SYSTEM: ADVANCED LIGO SUB-SYSTEM: SUS PART NAME: αLIGO, CO2 LASER PULLING MACHINE FIBRE CARTIDGE

SIZE: D DWG. NO.: D1001504 REV.: v4

REDLINE

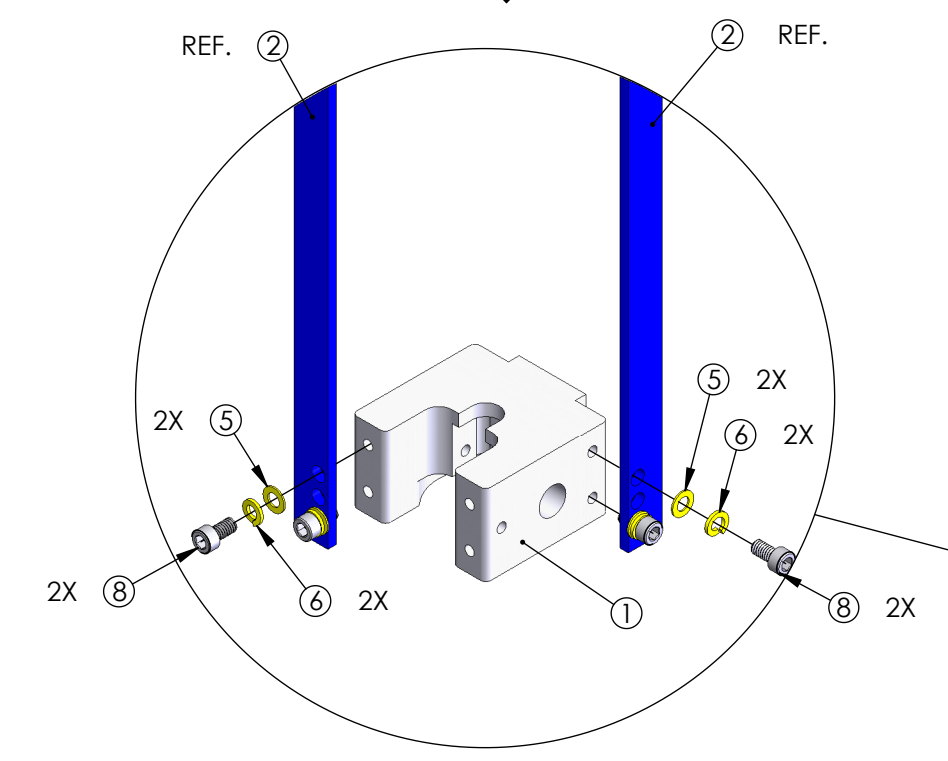
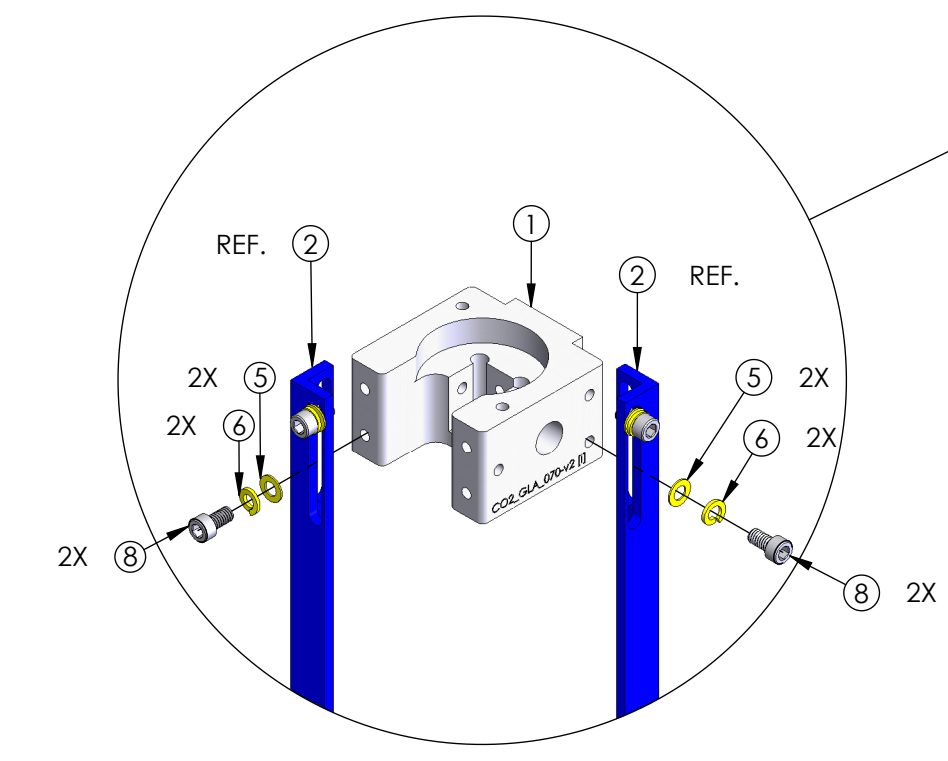
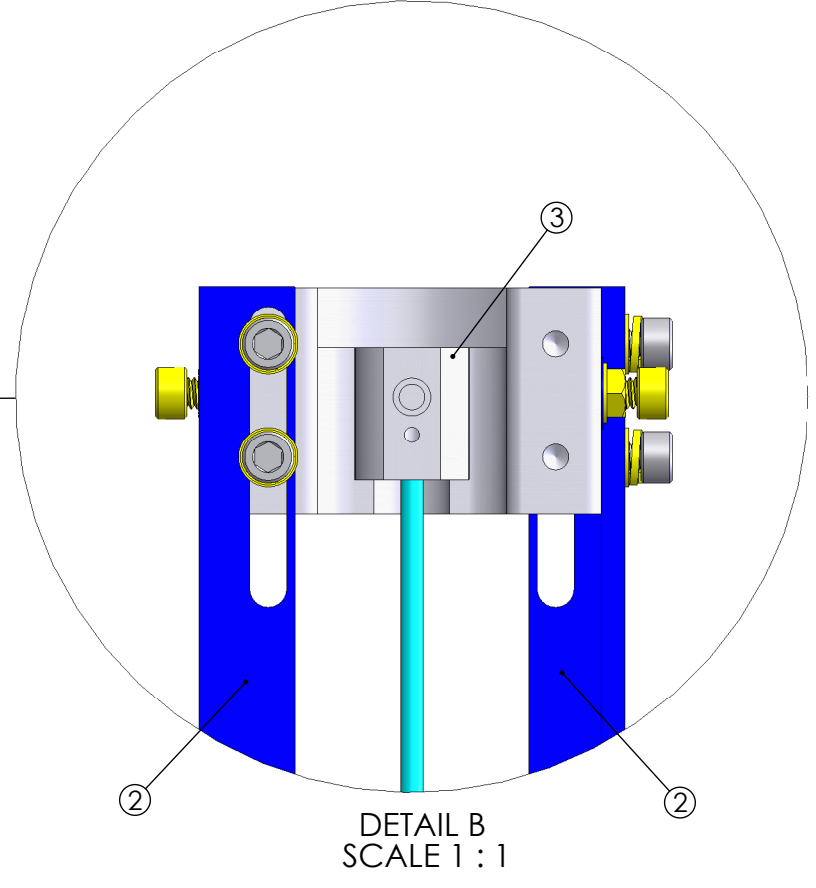
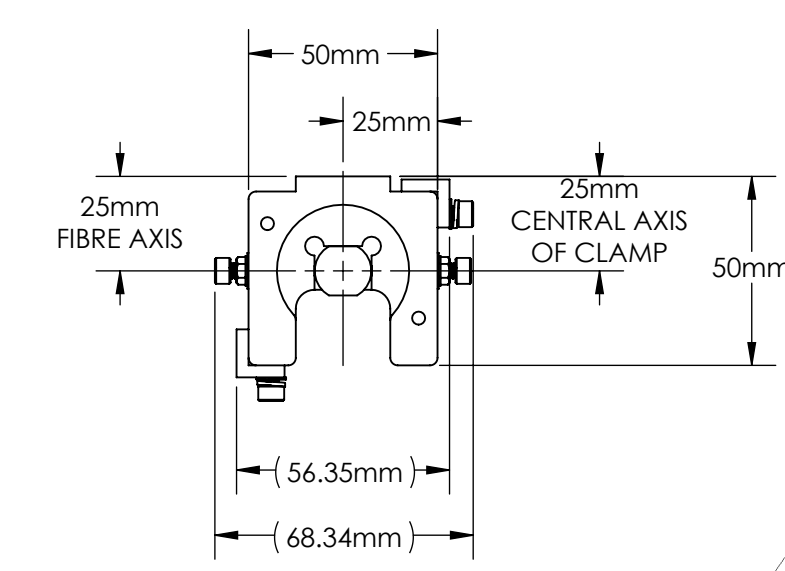
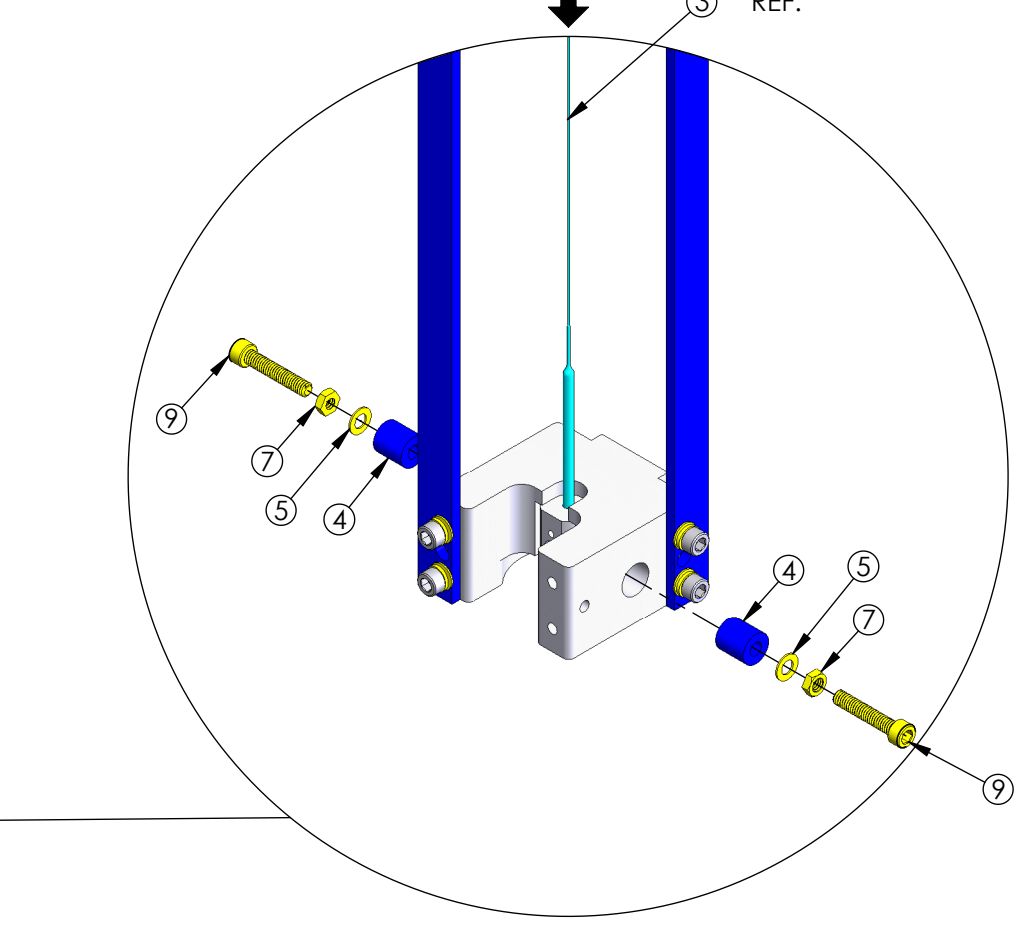
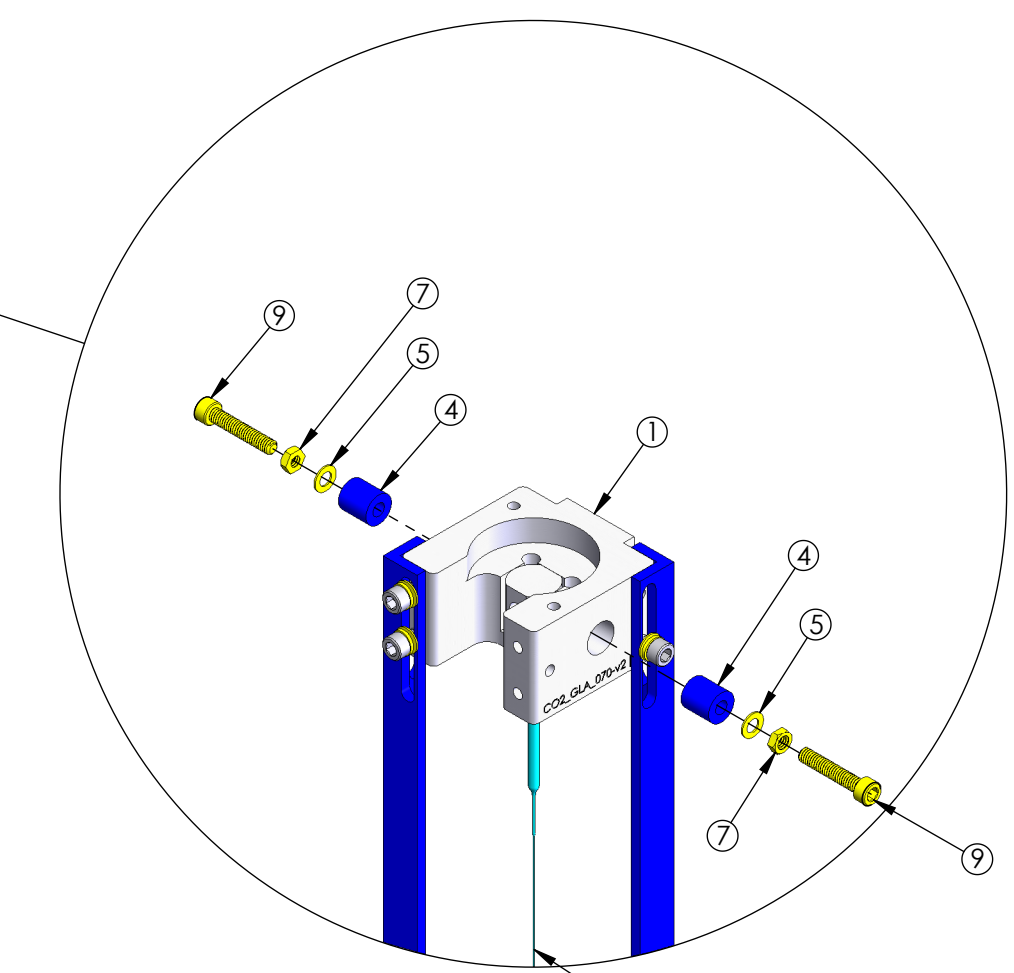
NOTE: ADD FLAT WASHERS AND LOCK WASHERS TO ATTACH THE STIFFENING RAILS TO THE PULLING CLAMPS TO MAINTAIN PROPER TENSION OF THE FIBRE

NOTE: USE SCREWS, WASHERS, SPACERS, AND LOCK NUTS ON BOTH SIDES OF THE CLAMP BLOCKS TO RETAIN THE "FUSE" ENDS INTO THE CLAMP BLOCKS TOP AND BOTTOM.
